# UNITED STATES PATENT AND TRADEMARK OFFICE

10/576,913

Roger Keith Todd

<b>Office Action Summary</b>	<b>Application No.</b> 10/576,913	<b>Applicant(s)</b> TODD, ROGER KEITH	
	<b>Examiner</b> CHRISTOPHER BOBISH	<b>Art Unit</b> 3746

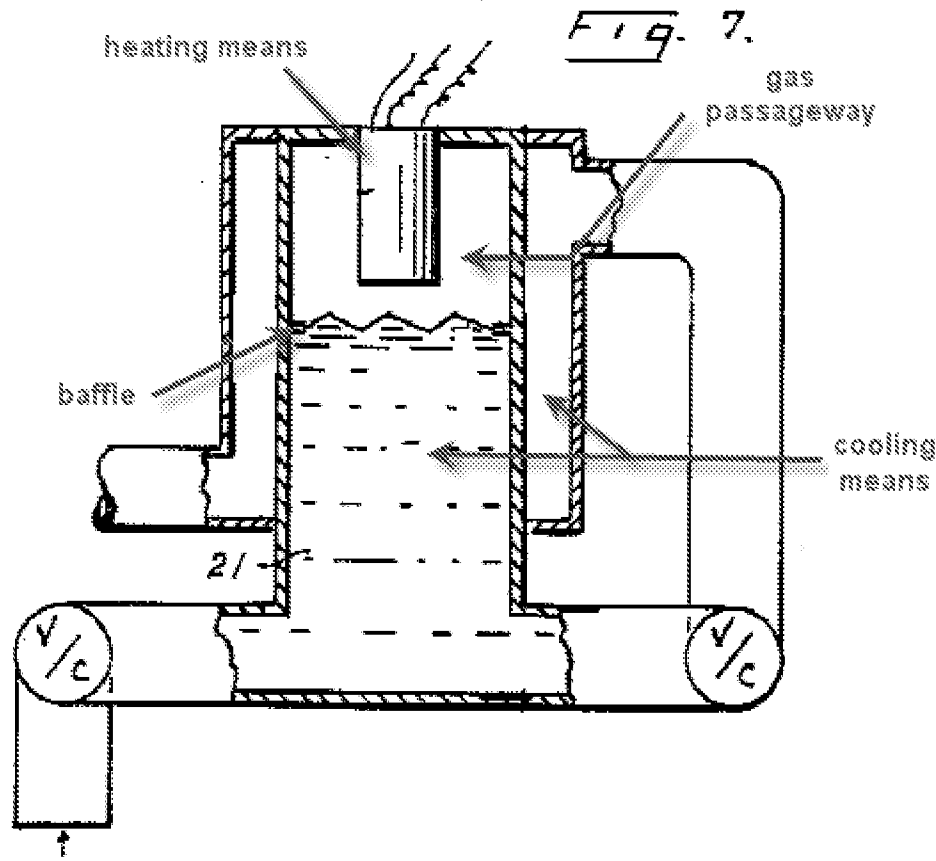
limitations from claims 4 and 21, wherein the pump body includes at least one baffle therein, the baffle defining a gas flow passageway between an inner wall of the pump body and the baffle, and wherein the gas flow passageway comprises a rising portion having the heating means arranged therein and a falling portion having the cooling means arranged therein **(see FIG. 7 below as adapted by the examiner)**;

limitations from claims 6, 7 and 8, wherein the gas flow passageway comprises a circular annular passageway **(the chamber 21 is circular and the passageway formed at the top end as shown in the drawing above will be formed in an annular manner about the element 17)**; comprising a substantially "P" or "Q" shaped passageway **(when viewed from above, the passageway around the element will appear as a substantially Q shaped passage)**;

limitations from claims 9 and 11, wherein the pump body **(FIG. 7)** comprises a first part **(A)** including a volume of gas and a second part **(B)** including a volume of liquid; and a diaphragm **(25)** arranged in the second part of the body to separate the first and second parts **(C. 6 Lines 17-33)**;

limitations from claims 19 and 20, wherein the heating means **(17)** is arranged above and offset laterally from the cooling means with no overlap **(see FIG. 7 with respect to the position of heating means 17 and the liquid which serves as the cooling means, relative to each other);**
